#### KAWARTHA PINE RIDGE DISTRICT SCHOOL BOARD

#### Interior Renovations to Camborne Public School

#### ADDENDUM NO. 1

Project: Kawartha Pine Ridge District School Board

#### 1. 1/A203: Floor Plan:

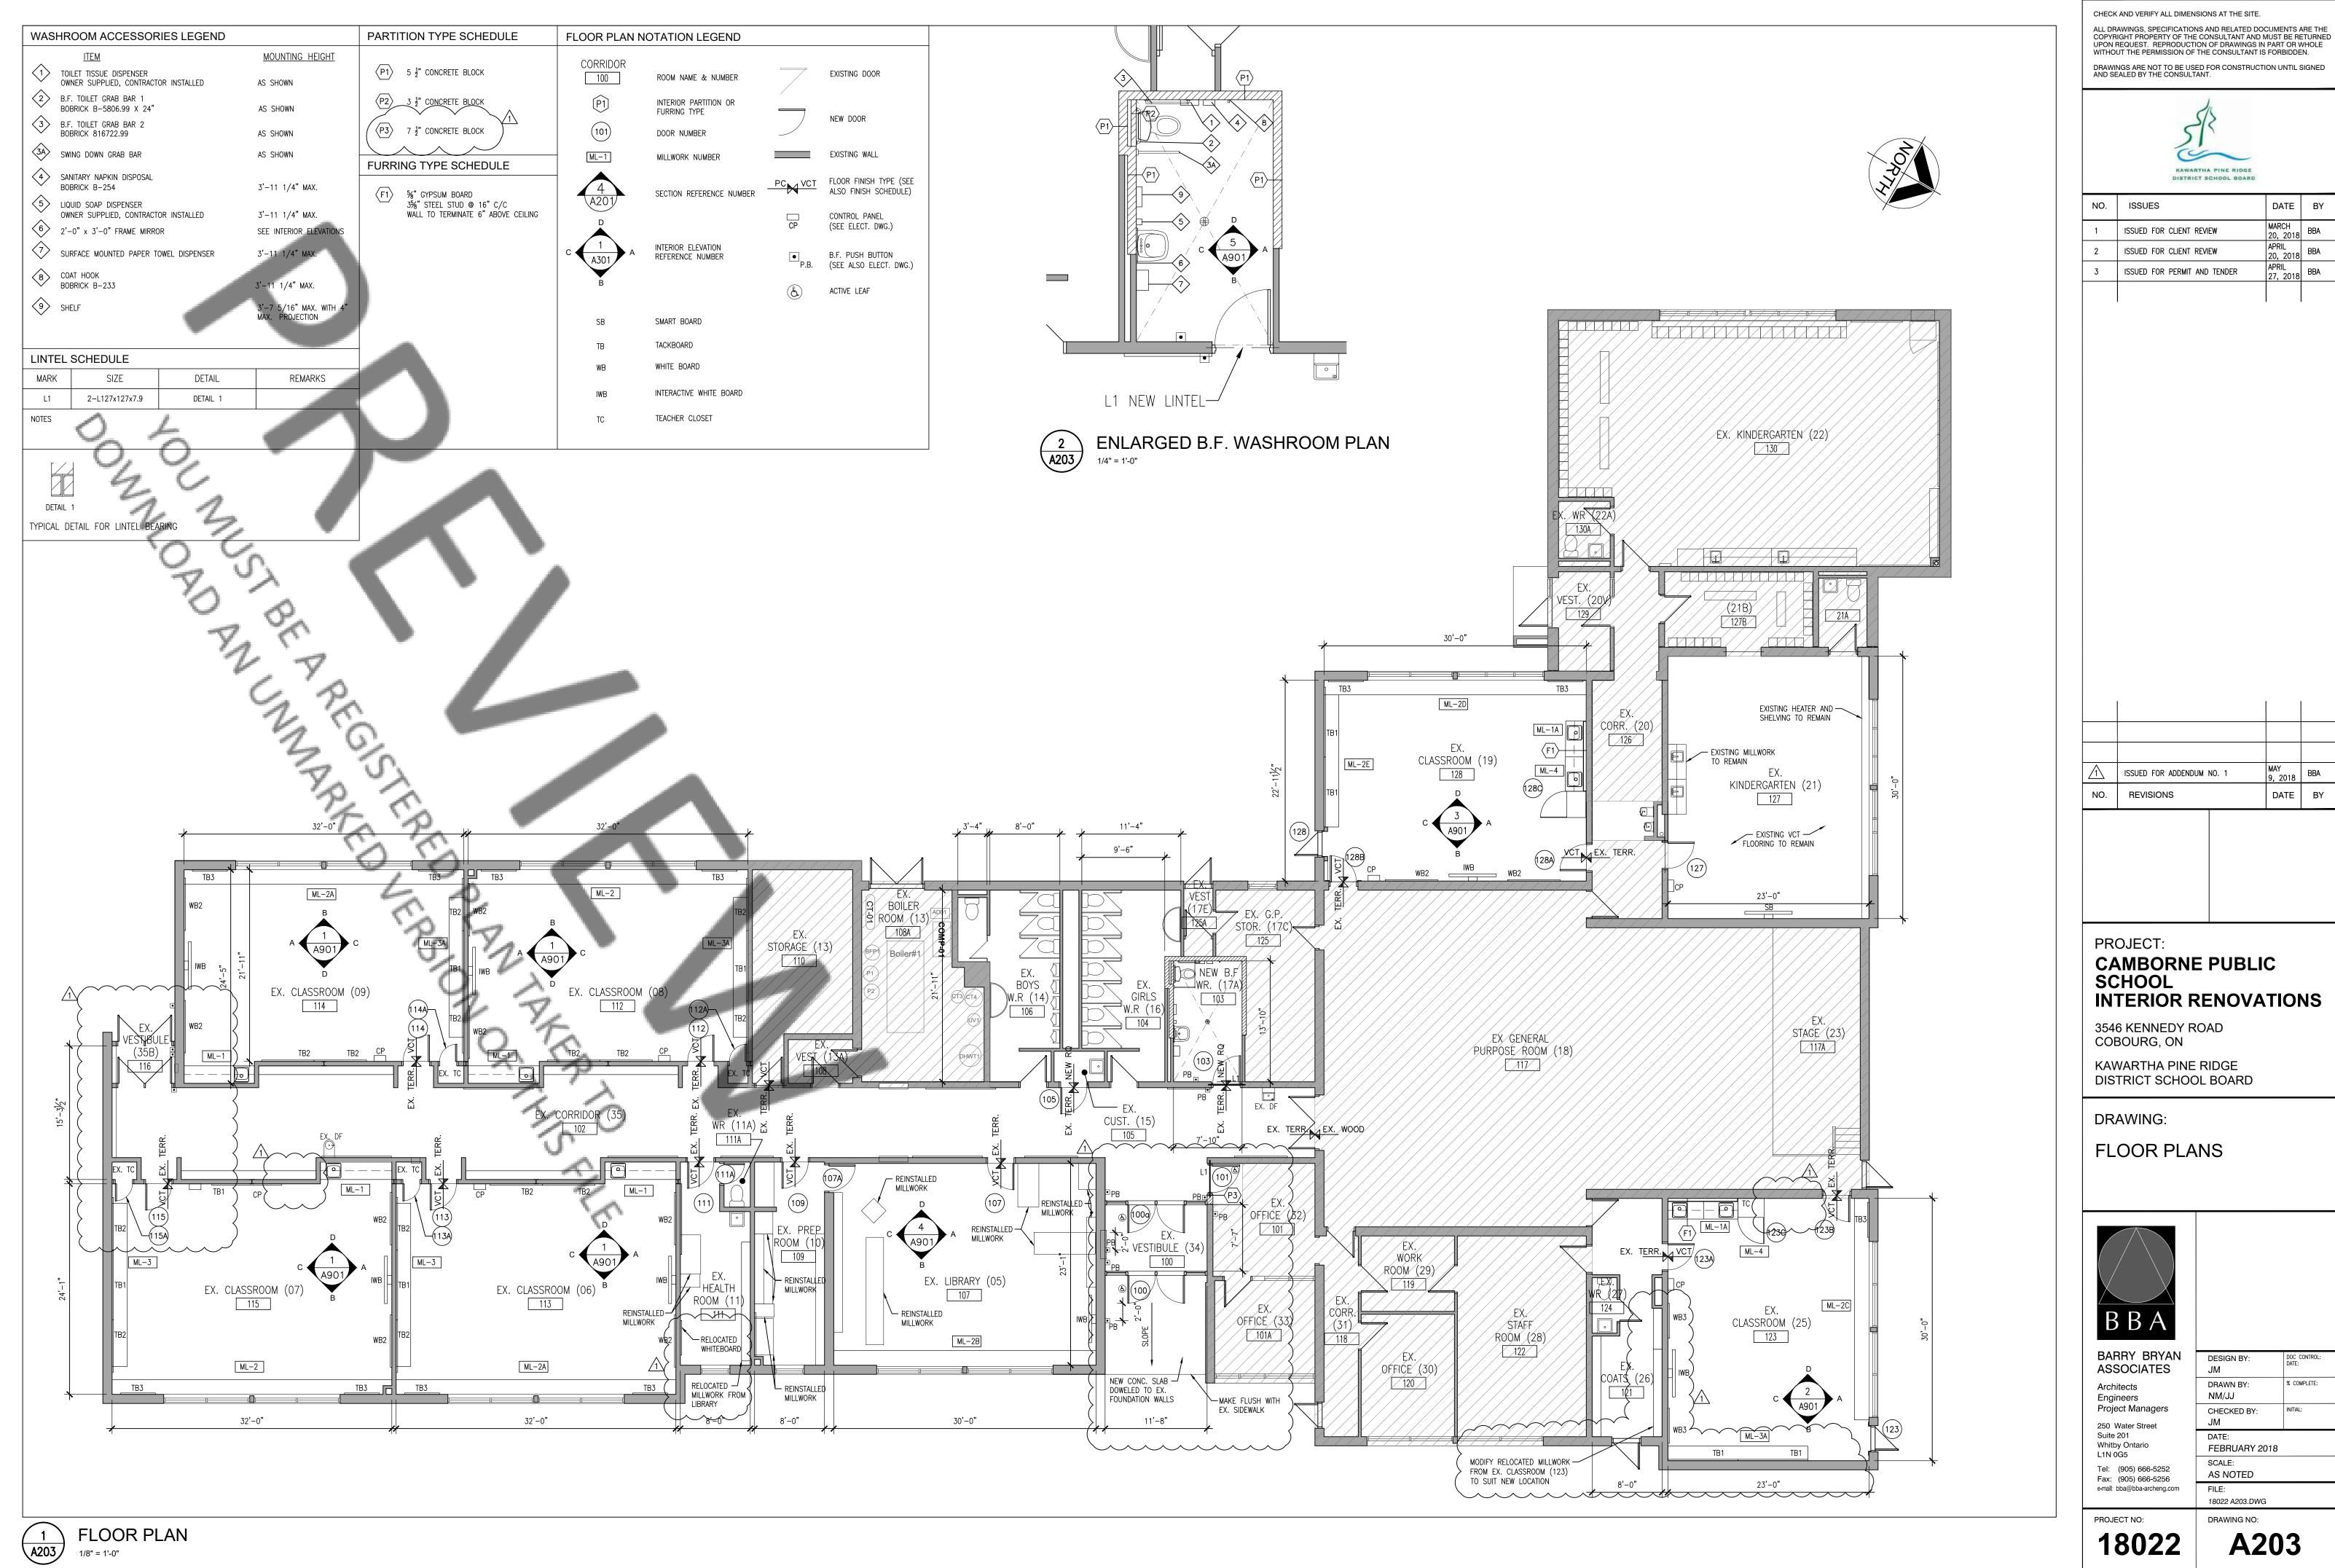
- 1. At the main entrance doors, provide new 5" thick concrete frost slab with welded wire mesh, so it is flush with the top of the existing floor slab and slopes down to be flush with the top of the sidewalk. Drill and epoxy 10M x 24" long dowels at 16" c/c, to tie the new slab into the existing foundation walls. Slab is to be on 2" Styrofoam SM rigid insulation on minimum 8" compacted clear crushed stone.
- 2. Existing Health Room 111: the relocated white board is shown on the south wall.
- 3. <u>Existing Vestibule 116</u>: the Existing Vestibule doors, power operators and push buttons are to remain. Paint doors and frames.
- 4. Existing Classroom 123: Delete new cubby Millwork ML-5 and ML-5A units. Instead relocate the existing shelf/coat hook millwork to the north wall of Existing Coats 121.

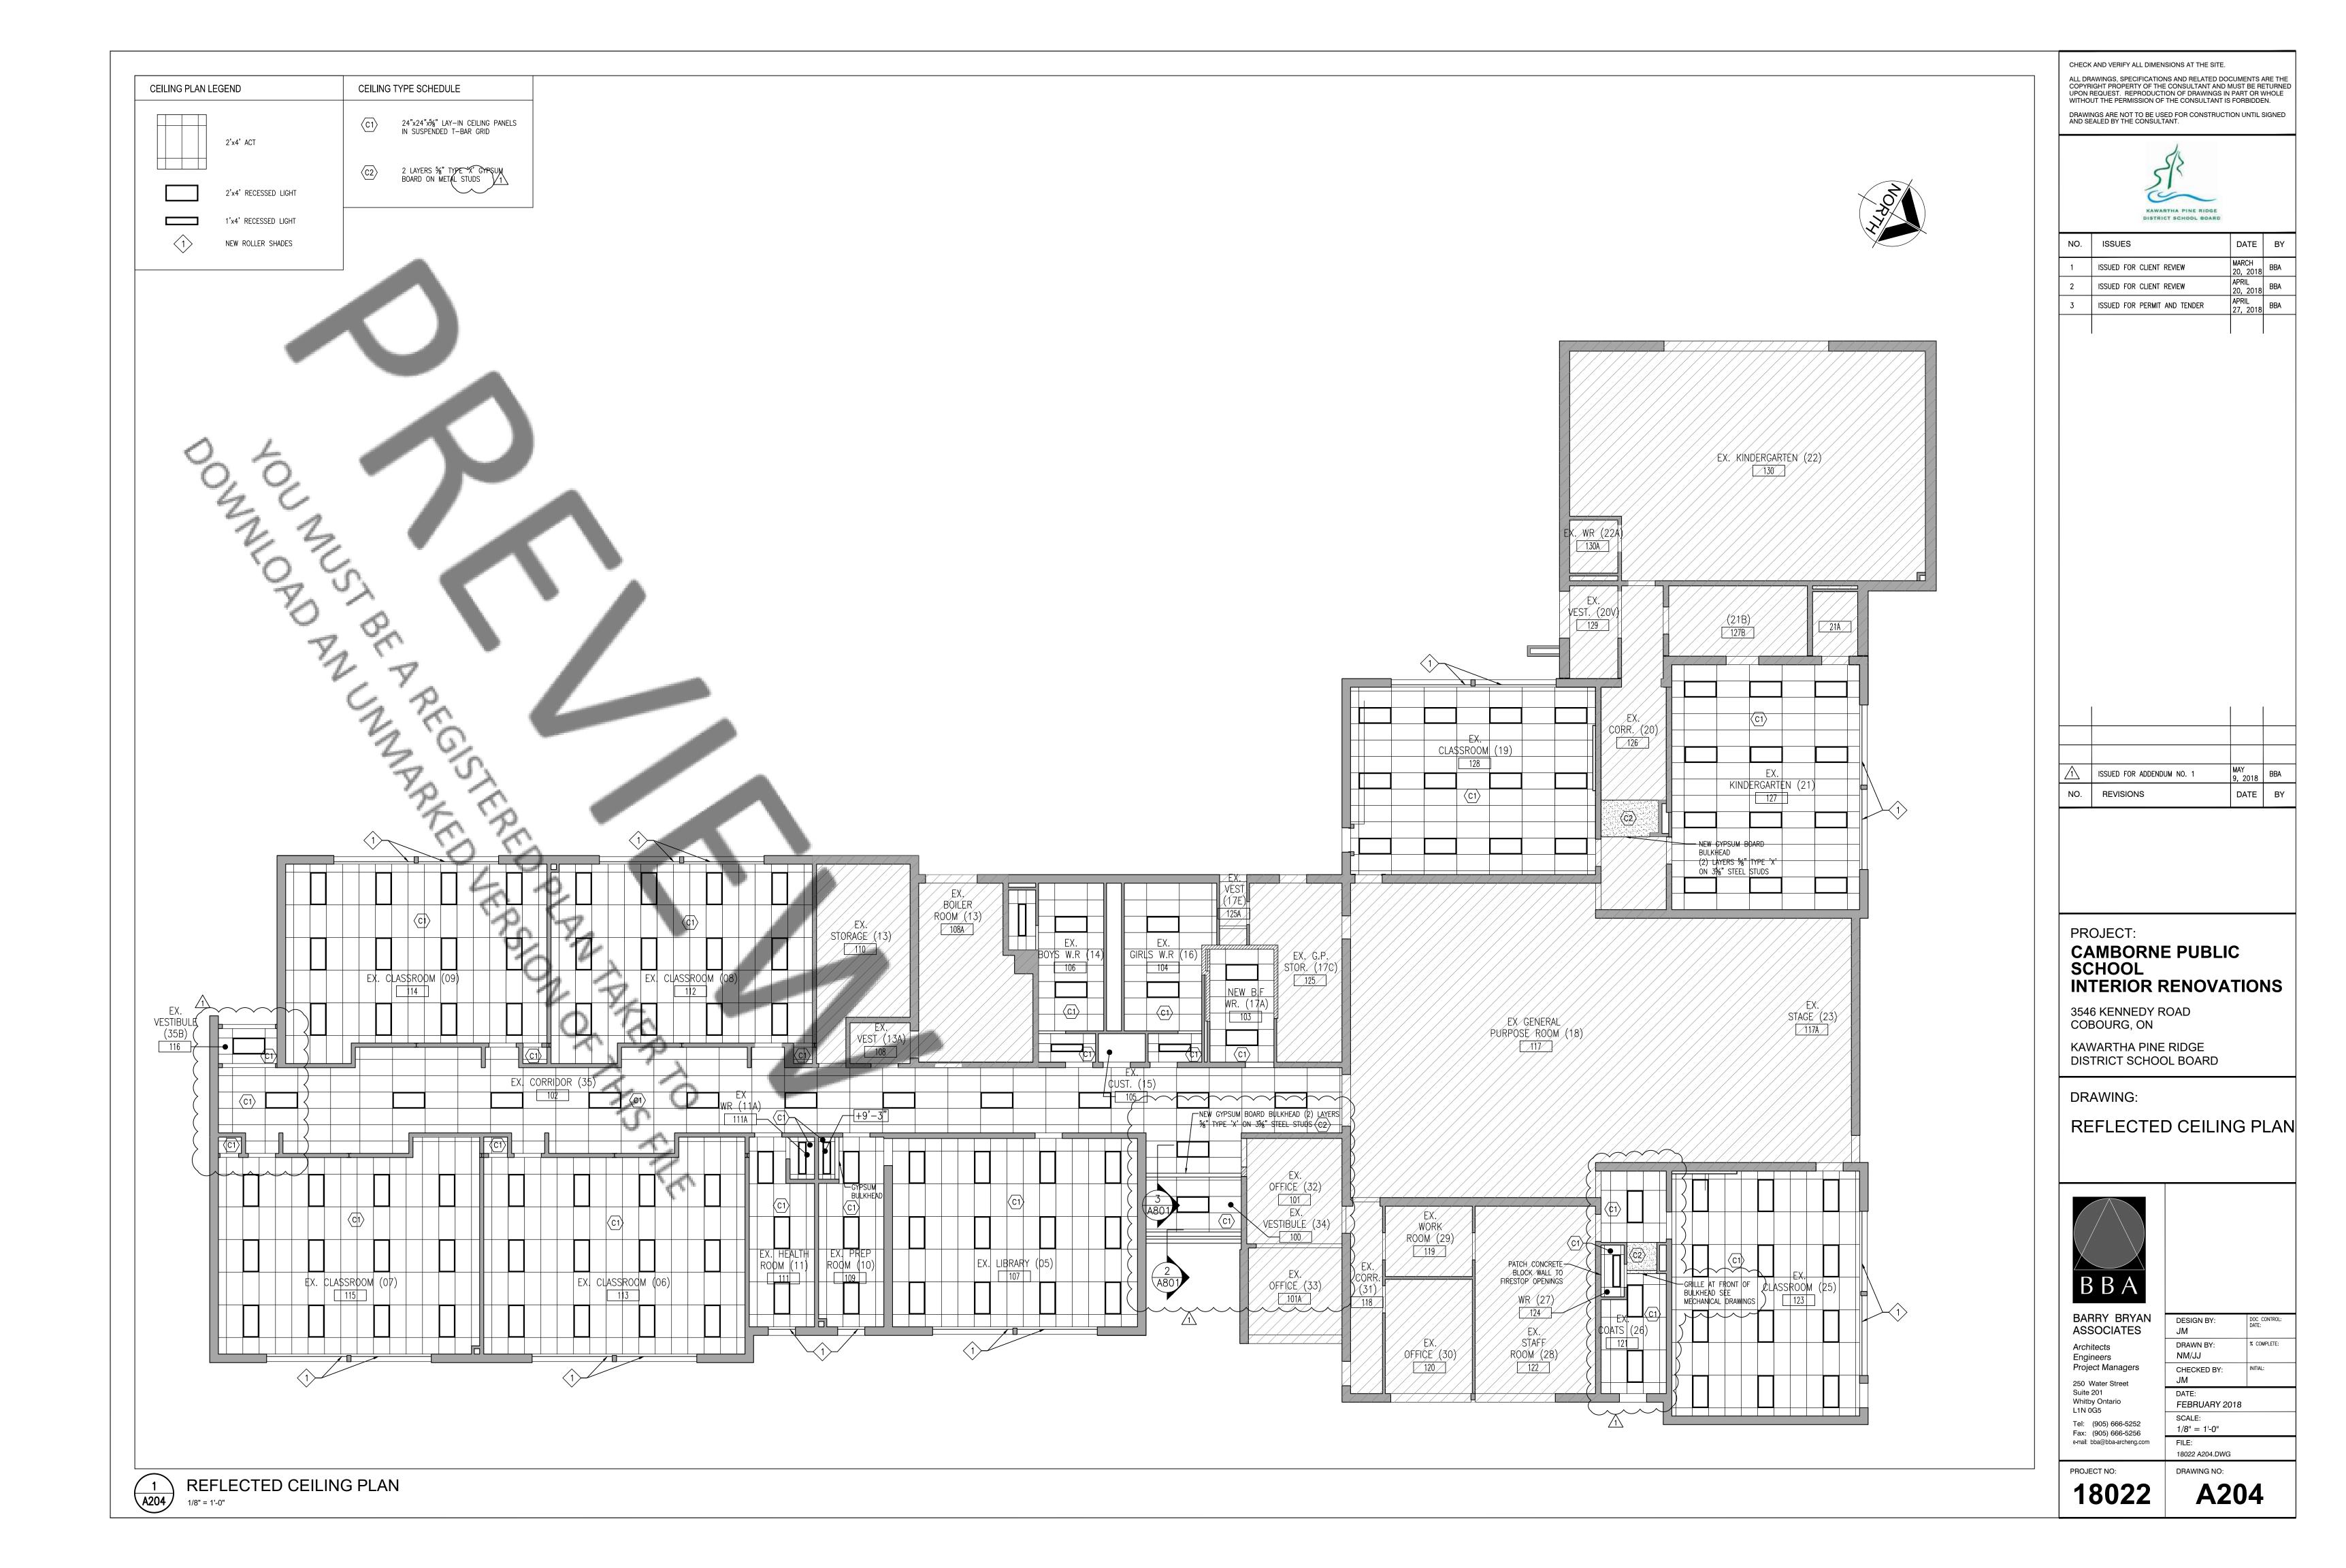
- 1. 1/A204: Reflected Ceiling Plan:
  - 1. Existing Vestibule 100: add bulkheads, as shown.
  - 2. Existing Office 101: new block bulkhead is added above new hollow metal door frame.
  - 3. Existing Vestibule 116: Existing bulkheads remain and are to be painted.
  - 4. Existing Coats 121: one 2' x 4' LED recessed light fixture is added to match the Electrical Drawings.

# **EXISTING CLASSROOM 123 INTERIOR ELEVATIONS**

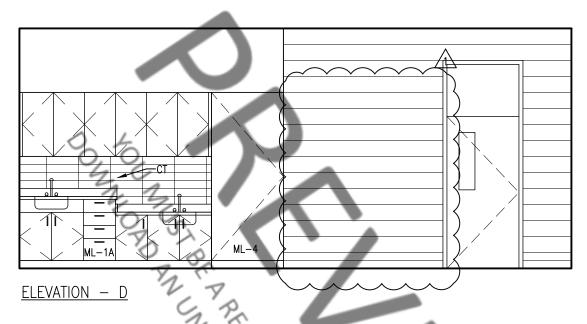
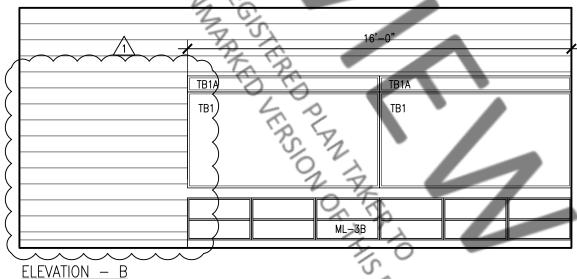
- 1. 2/A901: Existing Classroom 123 Interior Elevations:
  - 1. On Elevations B and D, delete cubby Millwork Units ML-5 and ML-5A. Existing coat racks are to be relocated to the Existing Coats Room 121.
